## **Alert Service Bulletin No. 072 Rev. A**

### **Master Contactor Replacement**

**Affected Master Contactor. Model Number STS-M12 Shown.  
Figure-1**

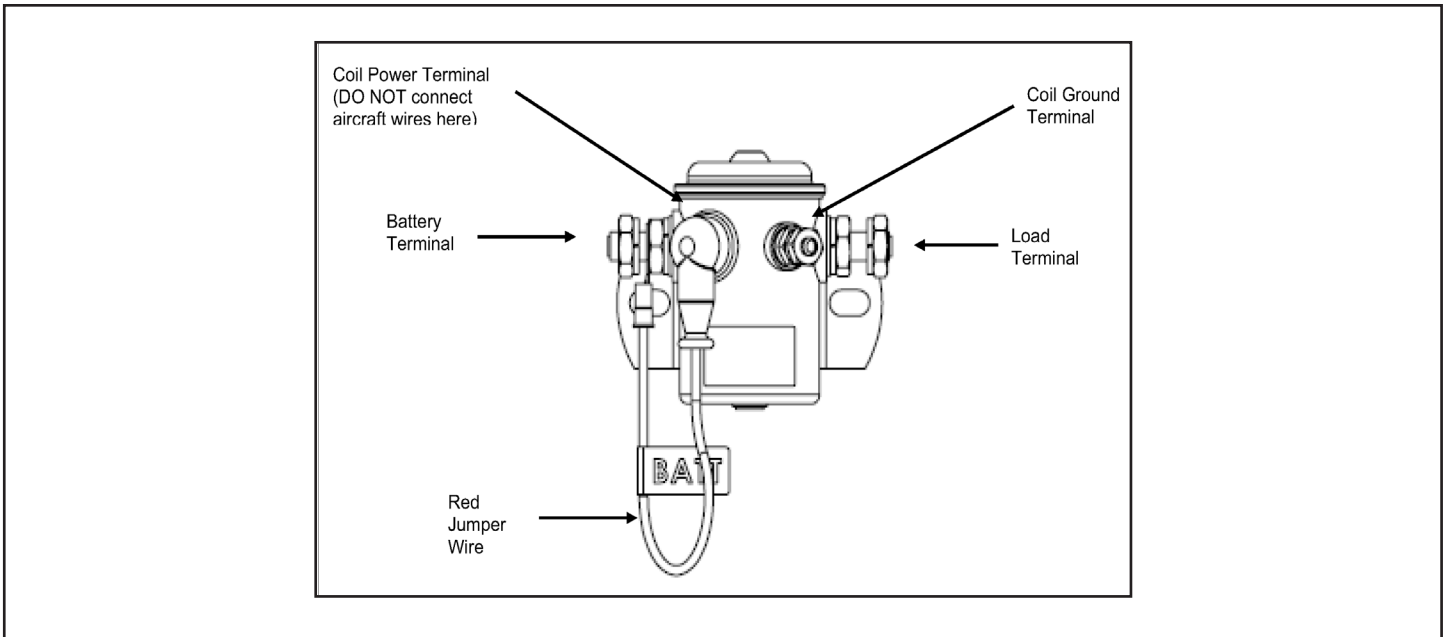
- (1) A design deficiency in the Master Contactor may cause a loss of contactor function when cycled, resulting in loss of aircraft electrical power.

- (1) This Alert Service Bulletin provides Instructions for Continued Airworthiness (ICA).
- (2) This Alert Service Bulletin provides instructions for replacement of affected HET Master Contactor part numbers STS-M12 or STS-M24 and affected HET Auxiliary Contactor part numbers STS-A12 or STS-A24 when installed as the Master Contactor.

- (1) At the next planned maintenance interval or within the next twelve (12) months, whichever occurs first, replace affected Master Contactor with one not affected by this Alert Service Bulletin in accordance with the applicable aircraft maintenance manual and/or service instructions and continue to “Return to Service” 3.C.(1).
  - (a) Refer to **Figure-2** for replacement contactor illustration. Sky-Tec Contactor P/N STS-M12 and STS-M24 with serial number H-R10001 and later will come with a red jumper wire installed from the Battery Terminal to the Coil Power Terminal. The jumper converts a 4-terminal contactor to a 3-terminal contactor.
  - (b) This configuration requires no alteration prior to installation. Use the vacant Coil Ground Terminal for control wire connection.
